PLANS

STATE OF NEW YORK
DEPARTMENT OF TRANSPORTATION
DESIGN AND CONSTRUCTION DIVISION
PLANS FOR CONSTRUCTING THE
EUCLID - NORTH SYRACUSE HIGHWAY

Field Change Sheets:
3F1, 5F1, 53F1, 12F1, 13F1, 13F2, 134F1, 135F1, 136F1, 137F1, 138F1, 139F1, 100F1, 101F1, 102F1, 103F1, 104F1, 105F1, 106F1, 108F1, 117F1, 119F1

As Built Revisions by Francis H. Backus
Approved: Eugene Parous, Asst. Contr. Supervisor, 3-27-1973
P.E. License No. 37013

FIELD CHANGE SHEET

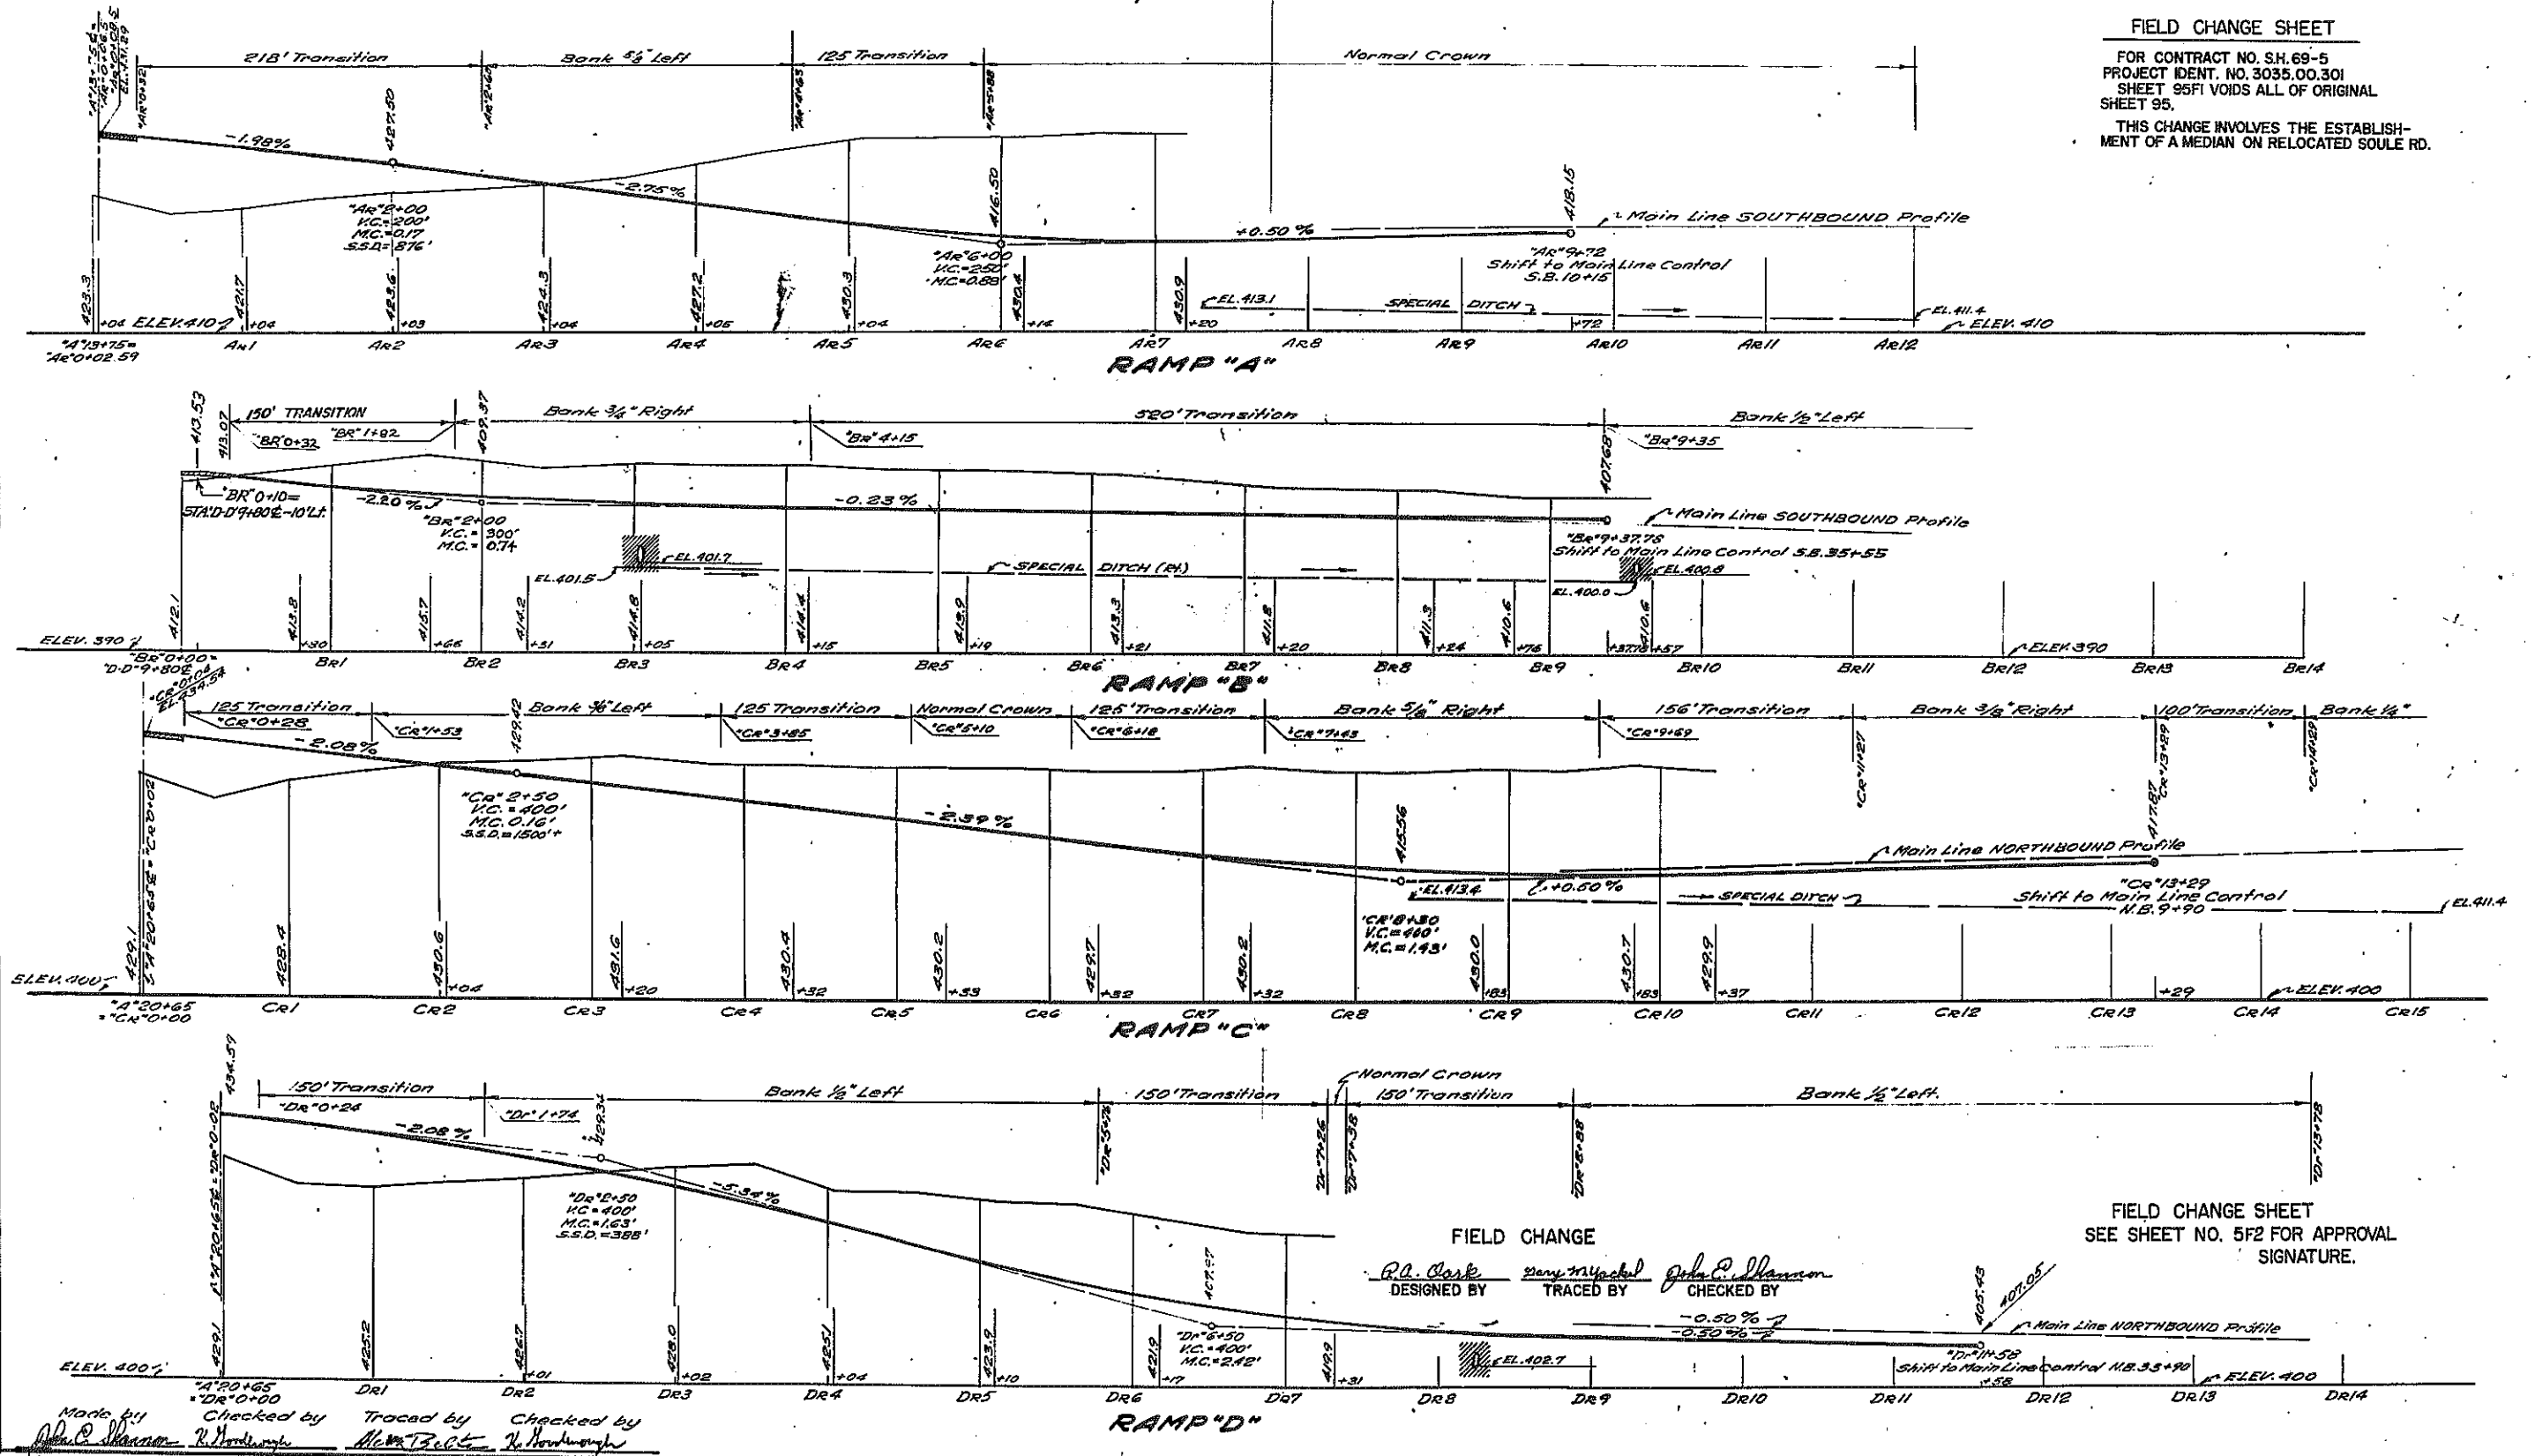
FOR CONTRACT NO. S.H. 69-5
PROJECT IDENT. NO. 3035.00.301
SHEET 95F1 VOIDS ALL OF ORIGINAL SHEET 95.
THIS CHANGE INVOLVES THE ESTABLISHMENT OF A MEDIAN ON RELOCATED SOULE RD.

Fed. Aid REG. NO.	STATE	Federal Aid Project No.	Sheet No.	TOTAL SHEETS
1	N.Y.		108	257

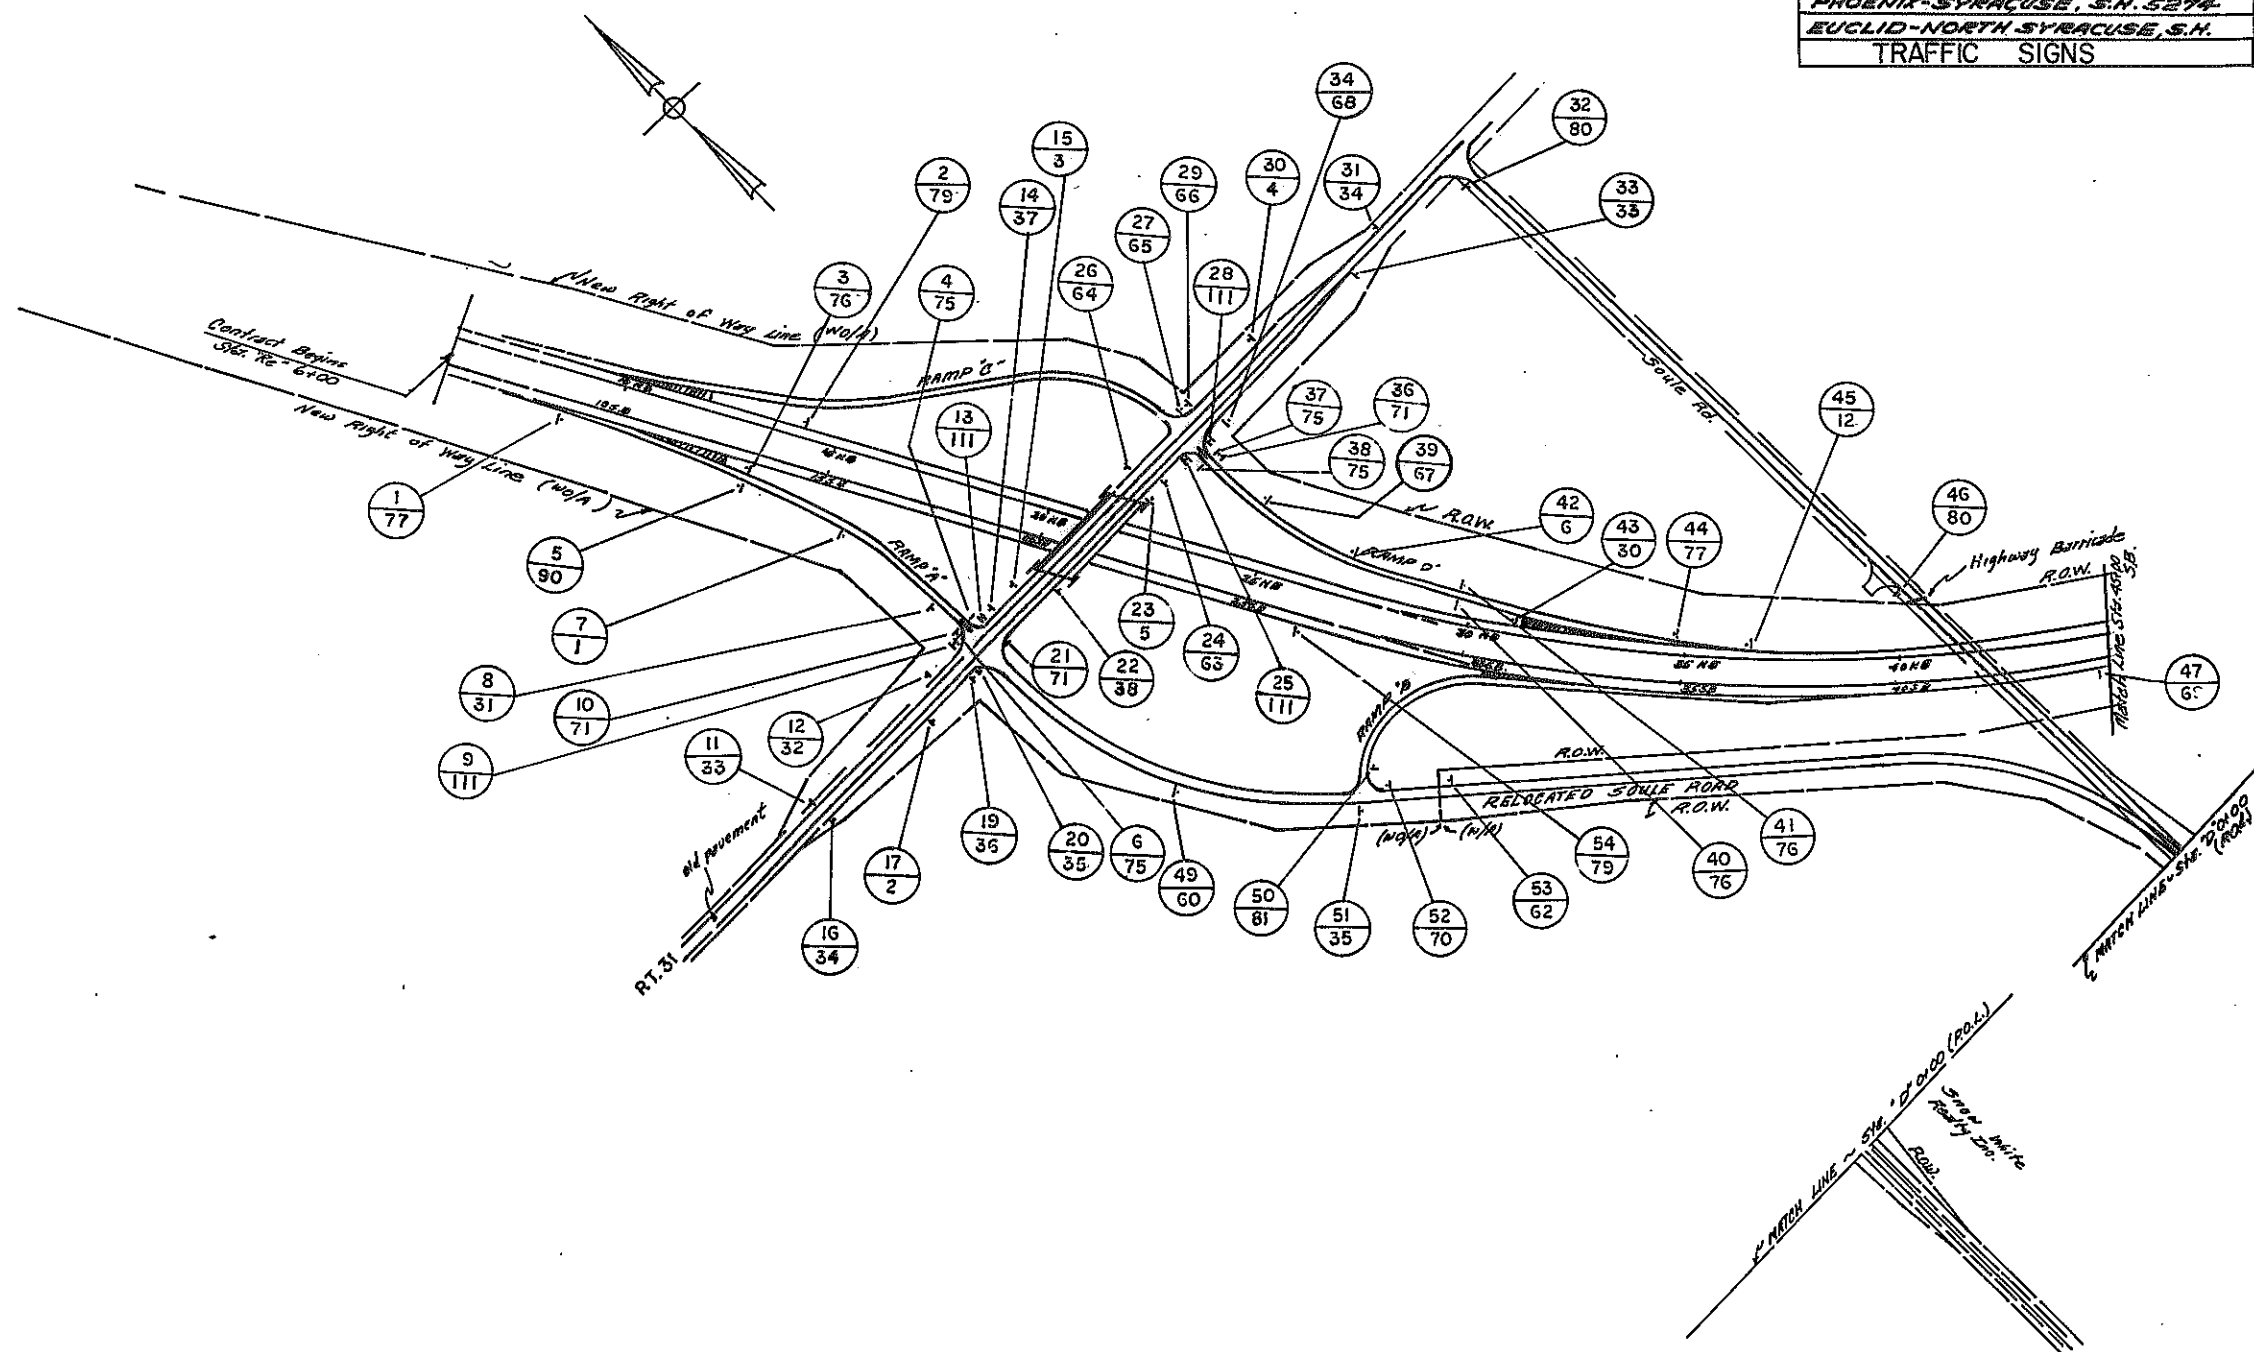
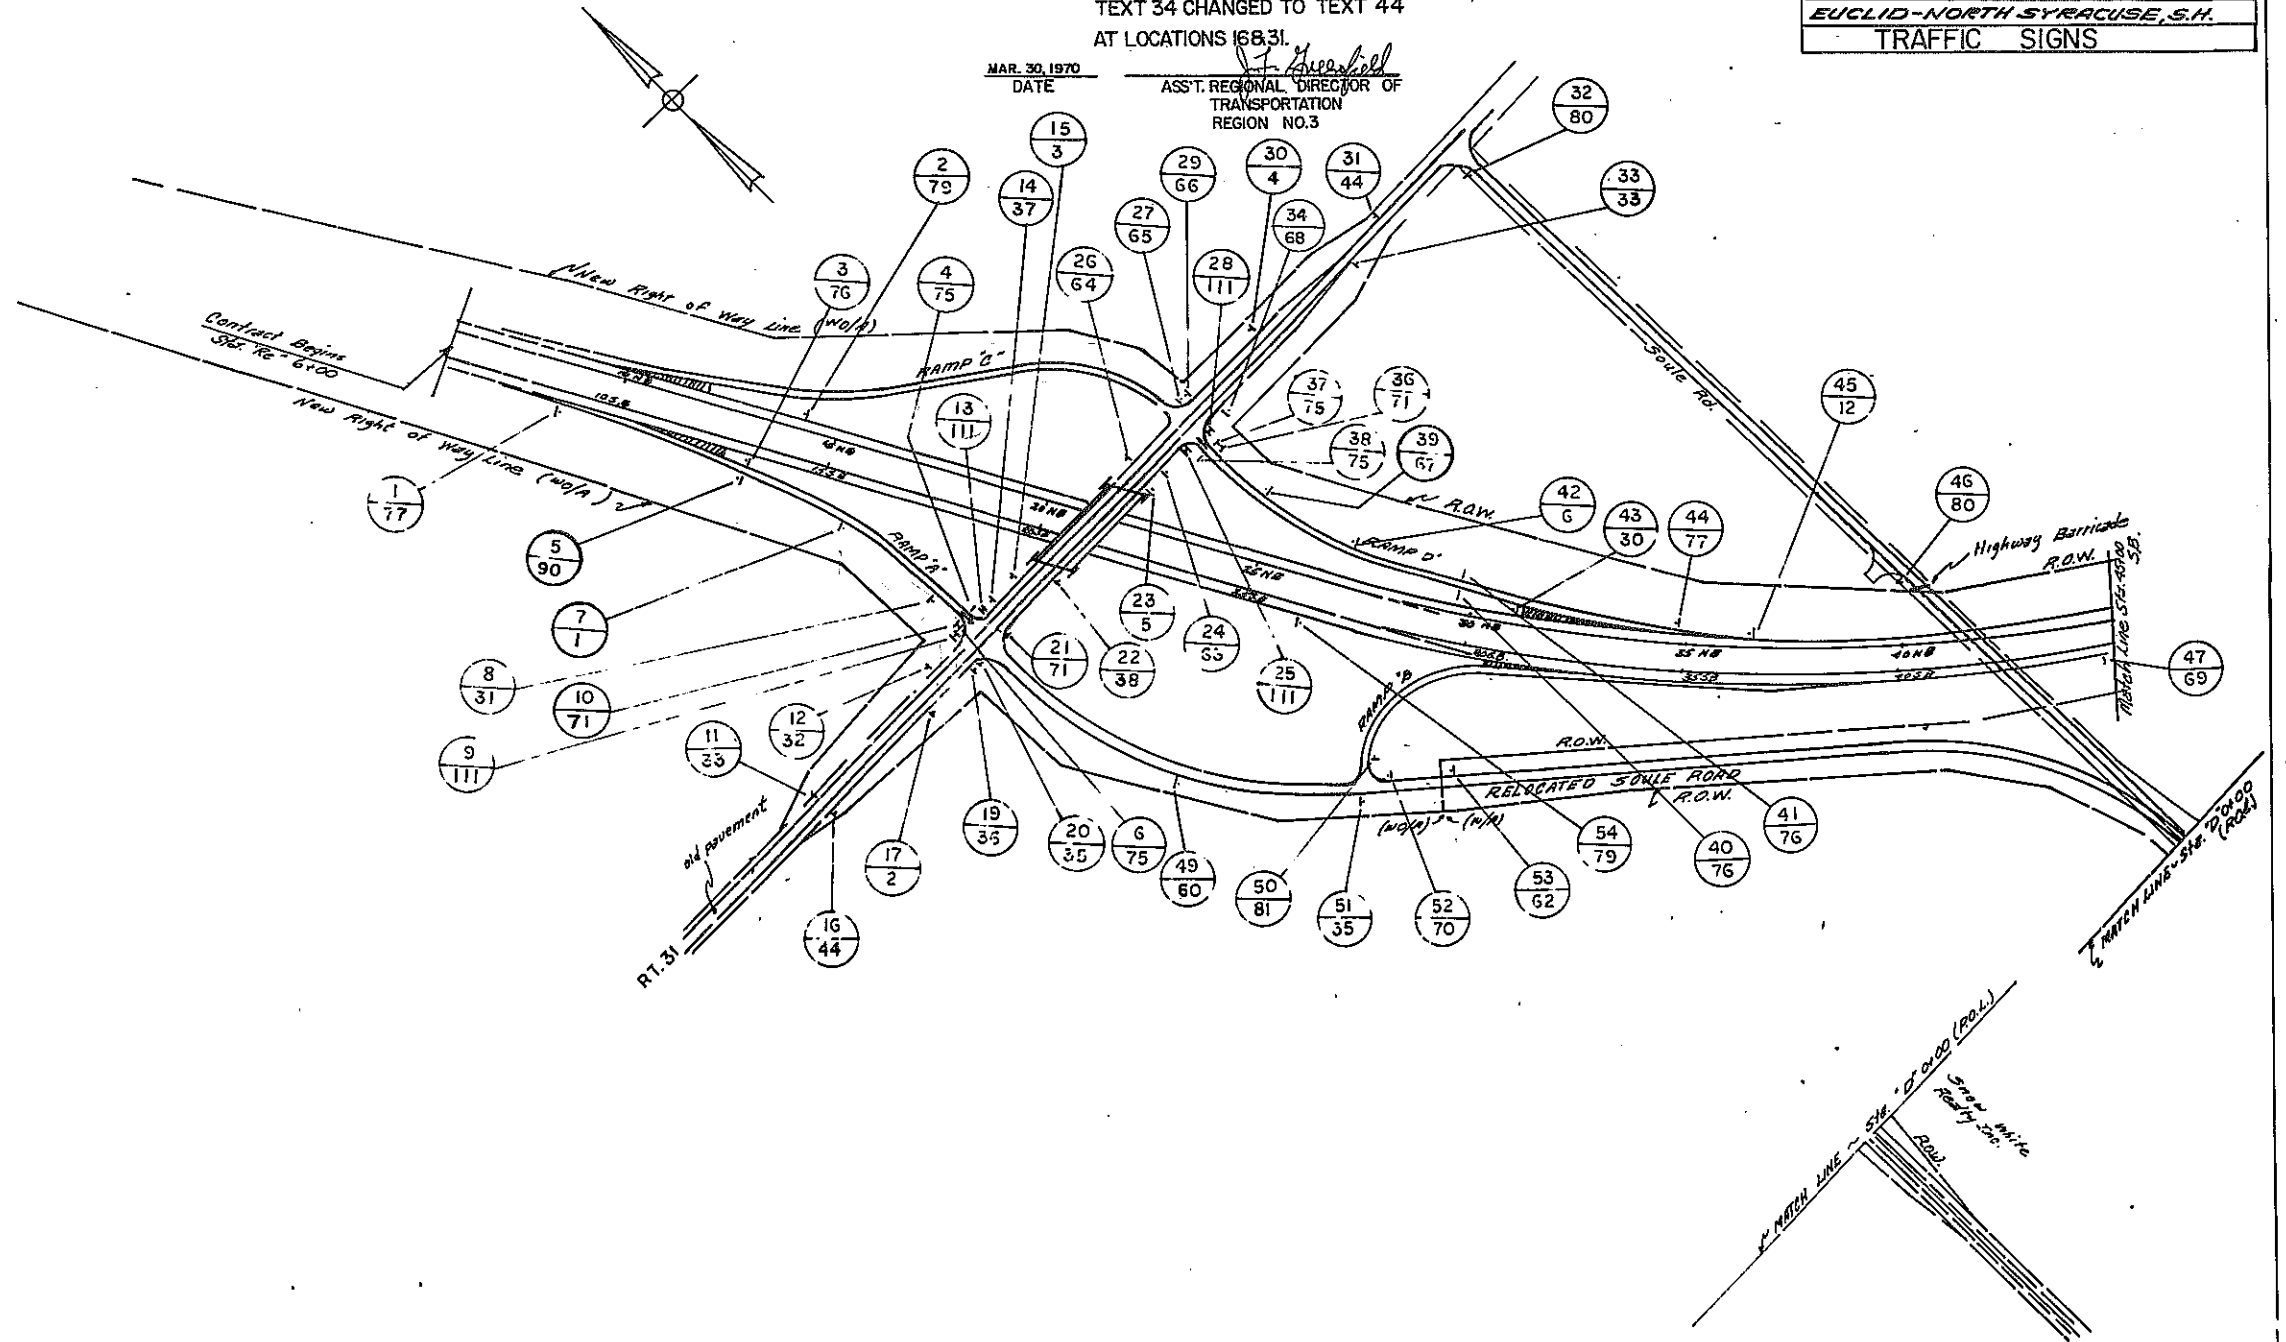
FIELD CHANGE
 SHEET 108F1 VOIDS PART OF
 ORIGINAL SHEET 108.
 TEXT 34 CHANGED TO TEXT 44
 AT LOCATIONS 168.31.
